Product Change Notice

JENSEN® JE3214

Old I/O

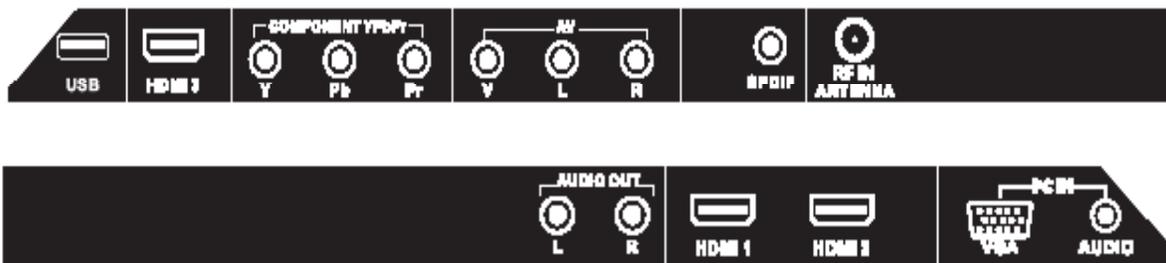
The JENSEN® JE3214 will be changing to a different IO configuration. The new Rev Level is denoted by "M" changing from the previous design of Rev Level "L". This change will be effective in September.

The new revision solution has common component/composite video input and shares the same I/O as Y/V (Yellow/Video). The TV detects if a CVBS or Y Pb Pr signal is connected automatically.

The Composite Video input is now shared with the Component Video input. It is no longer a separate Yellow input. HDMI1 now supports ARC 1.4, Audio Return Channel.
